**RE: Meadowlark Wind I LLC's Application for a Certificate of Site Compatibility
for the New Frontier Wind Energy Project in McHenry County, North Dakota
Case No. PU-11-69**

1. Certification Regarding Layout Modifications, with Exhibits (per Certification Provision No. 38).

29-Turbine Layout (July 2018) and Updated 29-Turbine Layout (August 2018)

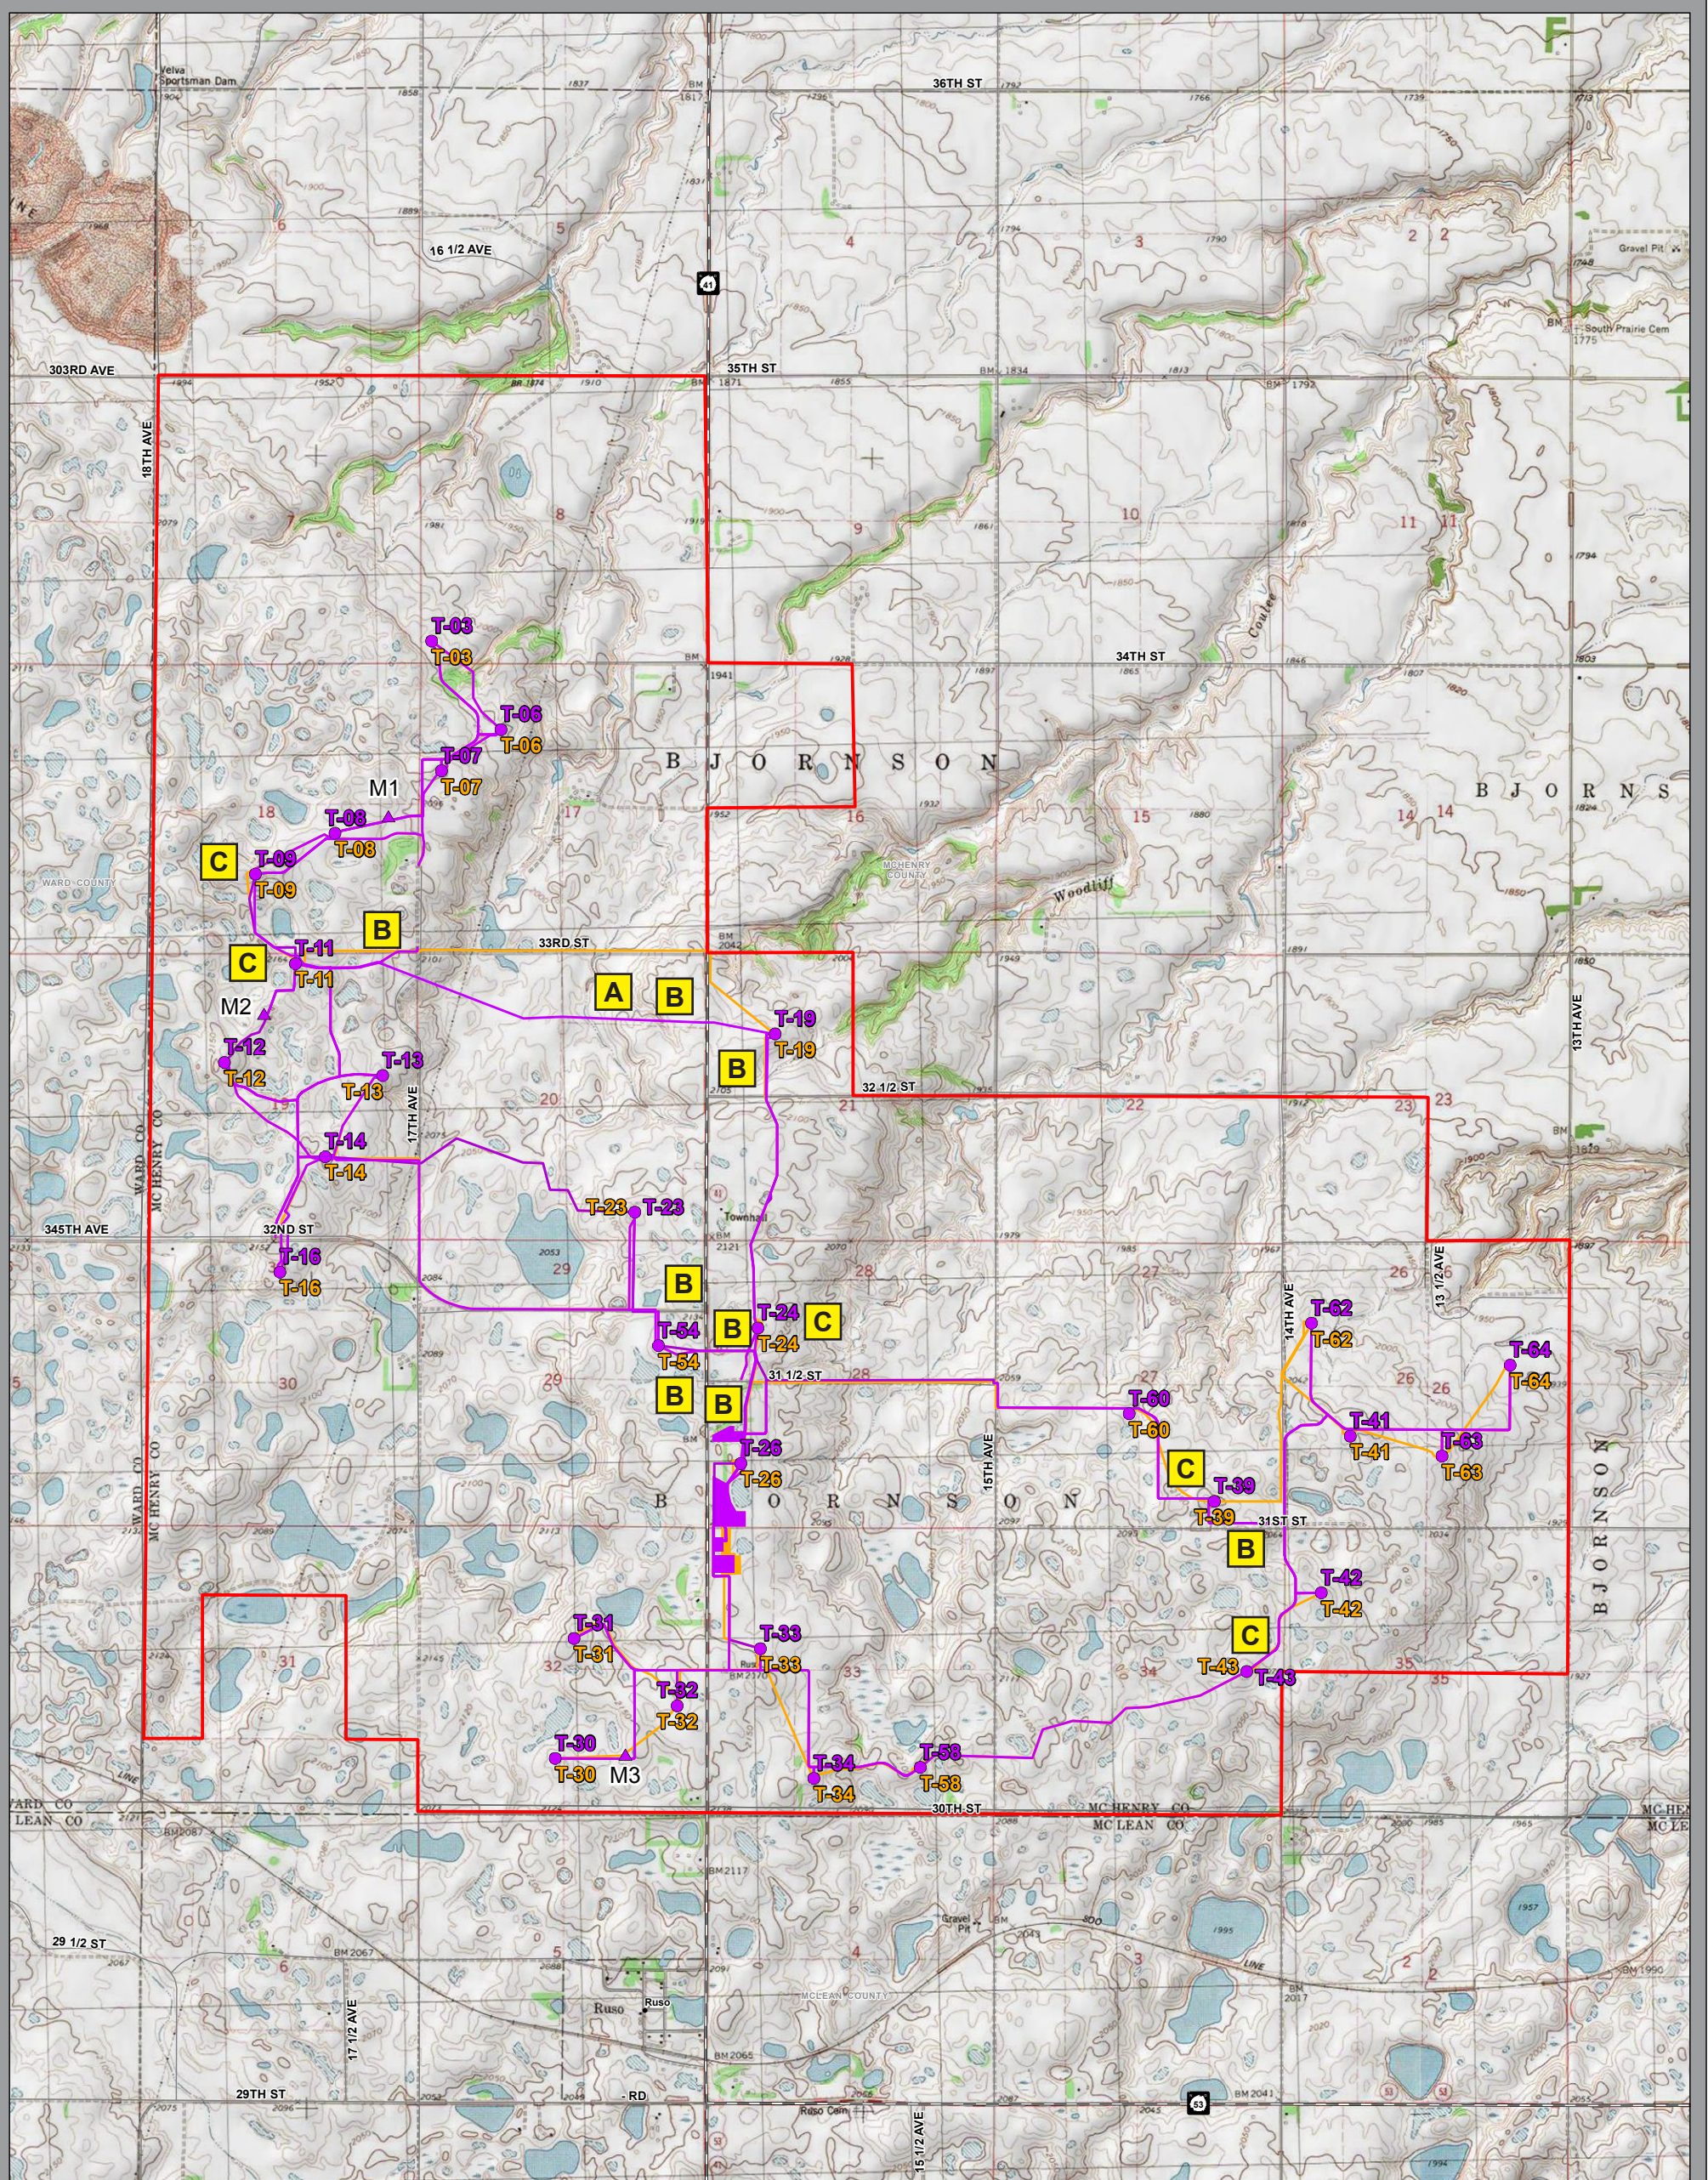
4. Since filing the Modifications Certification, Meadowlark has made additional minor modifications to the Project layout. A figure comparing the layout as submitted with the Modifications Certification to the current Project layout is attached hereto as **Exhibit A**.

5. The layout modifications include the following:

- a. A collection line has been added to the final design.
- b. Additional temporary workspace areas outside of previously surveyed areas have been identified.
- c. Five turbines have each been shifted less than 150 feet due to micrositing:
 - i. Turbine 9 was shifted to avoid a wetland within the area of turbine construction disturbance.
 - ii. Turbine 11 was shifted to avoid a wetland within the area of turbine construction disturbance.
 - iii. Turbine 24 was shifted in consultation with the Western Area Power Administration to avoid an existing microwave beam path.
 - iv. Turbine 39 was shifted due to constructability issues.
 - v. Turbine 43 was shifted to move permanent infrastructure away from the property line.

Layout Modifications
 A – Collection line added to final design
 B – Additional temporary workspace areas outside of previously surveyed areas
 C – Minor turbine shifts
